Draft decision

Jemena electricity distribution determination

1 July 2026 – 30 June 2031

Attachment 2 – Capital expenditure

Figure 2.1 Jemena’s historical and forecast capex (\$ million, \$2025–26)

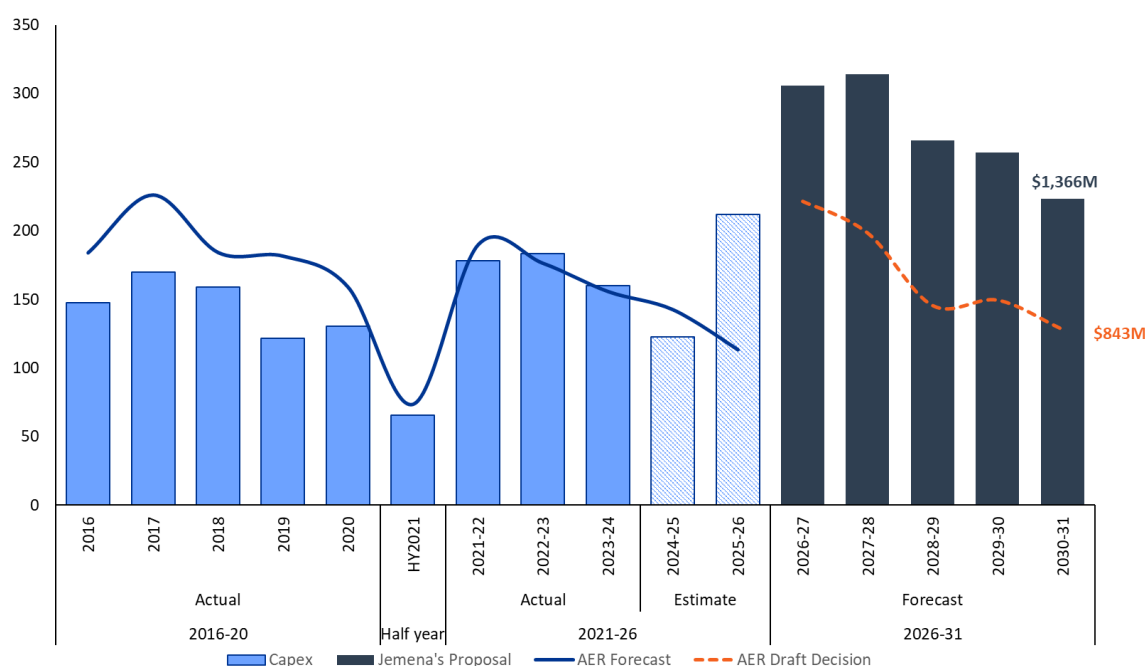
As can be seen in Figure 2.1, Jemena is proposing a material step up in the forecast period relative to the current period. We also observe a material overspend in the current period. The main driver of the overspend in the current period is due to increased data centre investment towards the end of the period.¹⁶

Figure 2.1 also shows that while our draft decision is a large reduction to Jemena’s forecast, it is broadly on trend with Jemena’s current period actual/estimate of \$836.4 million. As noted, our draft decision includes several placeholder values where we are seeking further information from Jemena in its revised proposal.
